CHARTER TOWNSHIP OF MERIDIAN
PLANNING COMMISSION
AGENDA

MARCH 28, 2016

The Planning Commission held a public hearing on March 14, 2016, regarding Mayberry Homes' request for tentative preliminary plat (TPP) approval of Silverstone Estates, a subdivision consisting of 25 single family lots on approximately 25.5 acres located on the east side of Powell Road north of Grand River Avenue. The site was recently rezoned (REZ #15040) from RR (Rural Residential) to RAA (Single Family-Low Density) with the voluntary offer of a condition limiting the number of residences to not more than one unit per acre. The proposed 25-lot plat is consistent with the condition.

HORZ SCALE: 1" = 60'
SHEET 2 OF 4

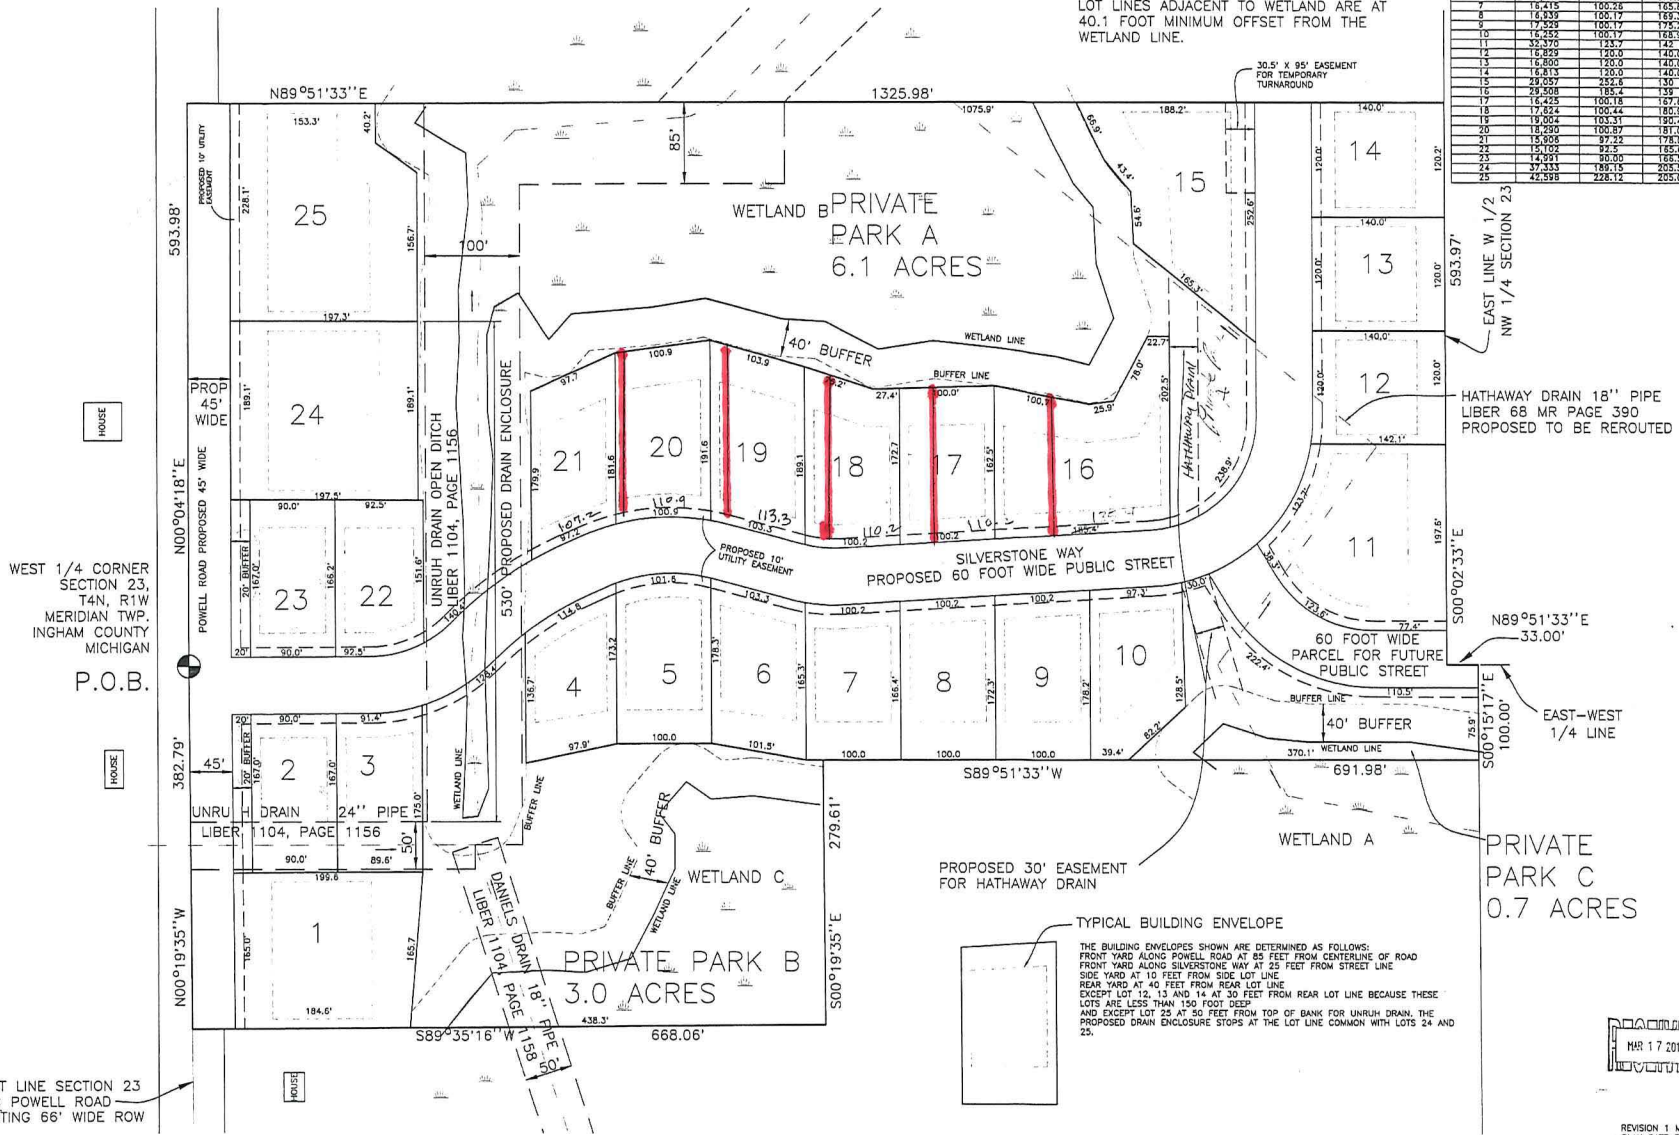
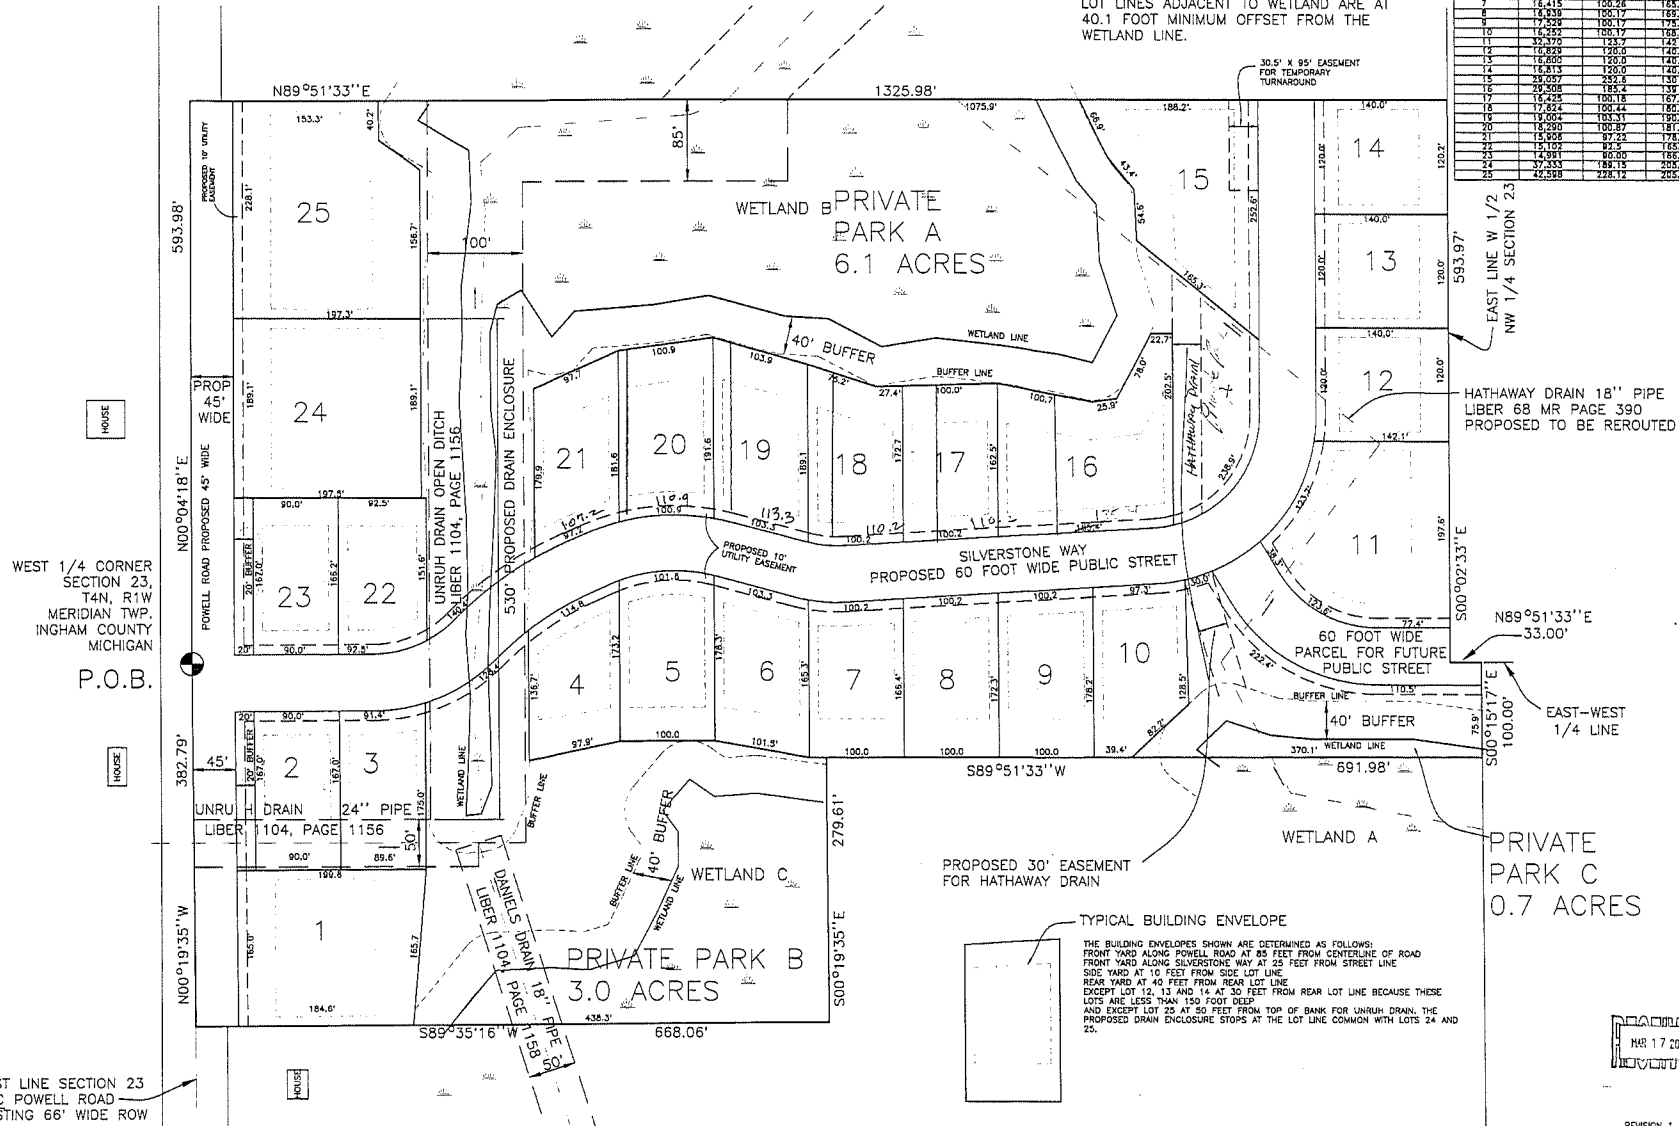
- Section 62-62(3) of the Land Division ordinance states "Where adjacent vacant areas are zoned or planned for development similar to the proposed subdivision, streets shall be extended to the boundary line of the plat to make provision for the future street connections." The plat plan has been revised and the cul-de-sac has been replaced with two stub streets ending at undeveloped RR (Rural Residential) zoned land located north and east of the proposed Silverstone Estates plat.

- Per Section 64-64(5), a 20-foot "landscape buffer" is required between the Powell Road right-of-way and the west side yards of Lot #2 and Lot #23. The plat has been revised to include the 20-foot landscape buffer. Lot widths for Lot #2, Lot #3, Lot #22, and Lot #23 have been revised since the original plat plan. The new widths are consistent with the minimum 90-foot requirement.

Staff has been advised the applicant will provide a revised lot layout for the north side of Silverstone Way, Lots #16 - #21 on Monday, March 28, 2016. The lot width for Lot #16 will be

reduced by 50 feet and 10 feet will be added to the lot width of Lots #17 through #21. The following chart shows the proposed changes. An example is attached with new lot lines shown in red.

Enclosed are twelve copies of Silverstone Estates with a realigned road plan. As we reviewed these plans we decided to adjust some of the lot lines. Specifically, we intend to reduce the road frontage lot 16 from 185 feet to 135 feet and increase the road frontage on lots 17, 18, 19, 20 and 21 by 10 feet each.

1. Approval is recommended based on the revised Tentative Preliminary Plat dated March 28, 2016, prepared by Enger Surveying and Engineering, indicating 25 single family lots, subject to revisions as required.
